QPCN13009

Change reel material comparison report

Involved package: Axial lead (DO-34, DO-35 & DO-41)

Structure compared:

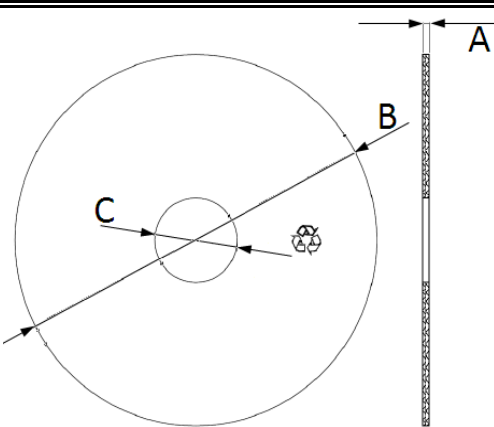
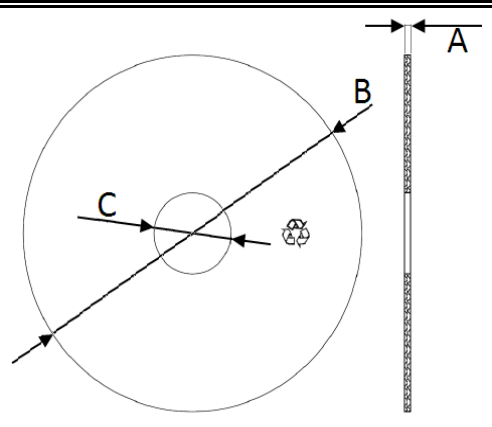
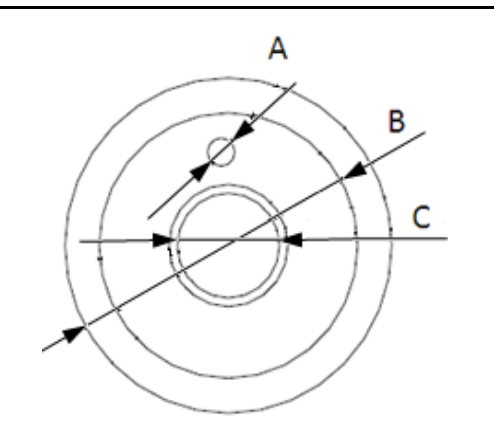
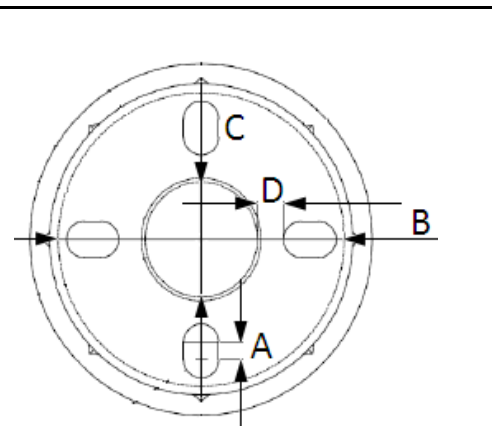
Old	New	Result
Photo (obverse side)			a) The paper structure has changed. b) The reel cap structure has changed.
Photo (reverse side)			
Photo (lateral view)
